**PRELIMINARY DRAINAGE REPORT
FOR
FLYING HORSE NORTH PRELIMINARY PLAN
AND
FINAL DRAINAGE REPORT
FOR
FLYING HORSE NORTH FILING NO. 1**

**NOVEMBER 2017
Revised April 2018**

CCER Response

Job no. 1096.11
PCD File No. SF-18-001

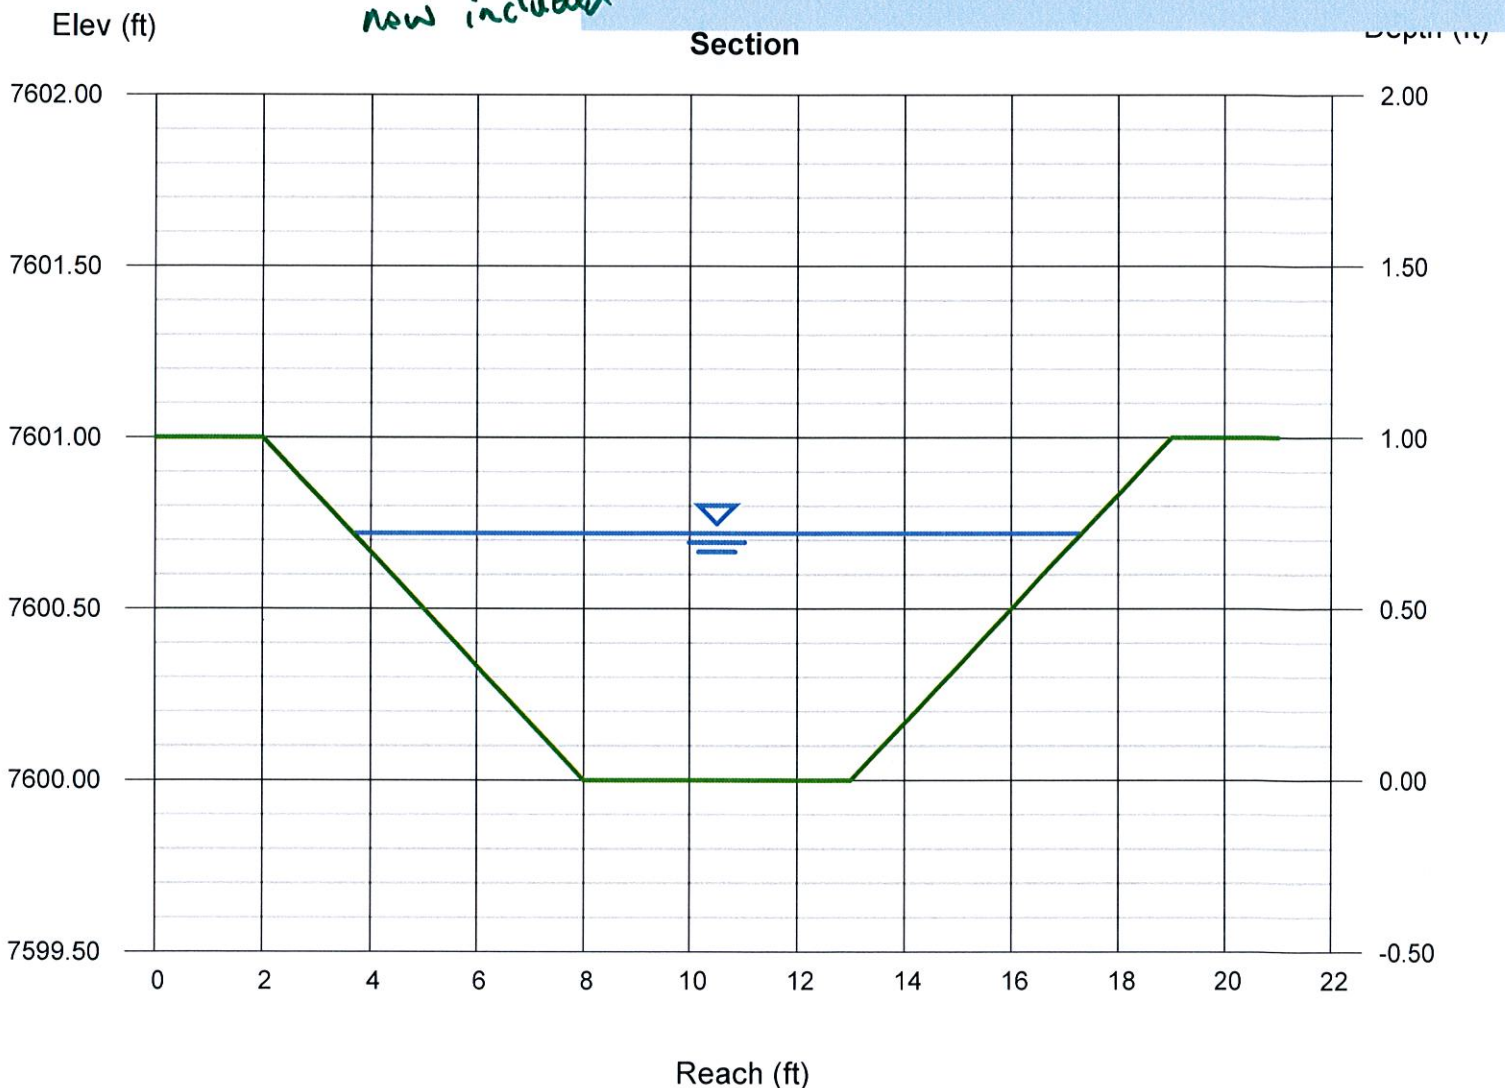
1. Provide road side ditch analysis with recommendations for ditch lining. Given the steep slopes on sections of the proposed road network, additional erosion protection. **Unresolved. Must be provided prior to final submittal. Depending on the analysis, it may impact other documents such as the construction drawings and Financial Assurance Estimate.**

Added E.C.B. to FAE and seeding already covered in grading bond.

See additional narrative
pages 5-6 and calcs
in Appendix.

Highlighted
